Proposal for Supplement 4 to the 02 series of amendments to UN Regulation No. 129 (Enhanced Child Restraint Systems)

Submitted by the expert from France

**"Figure 5
Lower strap anchorages (LSA 1, LSA 2, LSA 3 and LSA 4)**

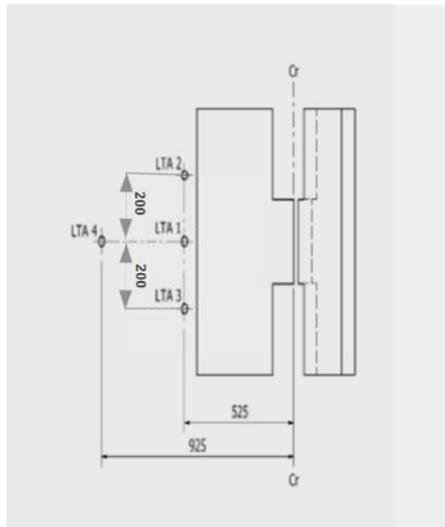
Annex 6, Appendix 2, insert new figure 5:
